BRAND: SCHULT
SERIES: LGH0028
CMH

DRAWING TITLE: ELECTRICAL PLAN

MODEL NAME | SQ. FT. 1600
PLANT 958 | DESCRIPTION 28X60 3BR-2BA | MODEL NO. 2772-CAPE
DRAWN BY MPS | ORIG. DATE 04/18/2005 | DATE PRINTED 05/25/2005 | SHEET NO 11-1

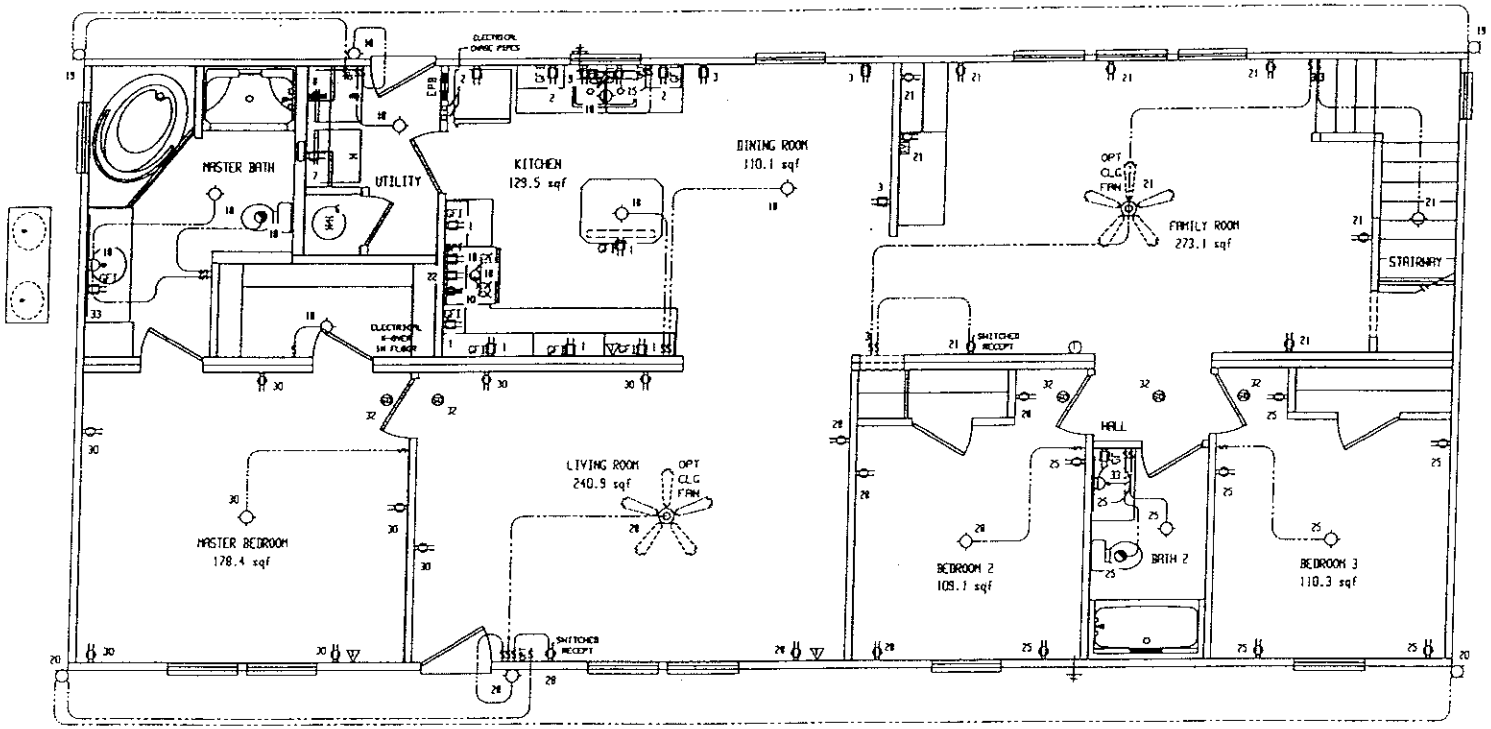
NOTE: ON MODULARS, ALL 15 & 20 AMP CIRCUITS FEEDING ELECTRICAL OUTLET IN BEDROOMS MUST BE PROTECTED BY AN ARC-FAULT INTERRUPTER IN ACCORDANCE WITH SECTION 210.12 OF THE NEC
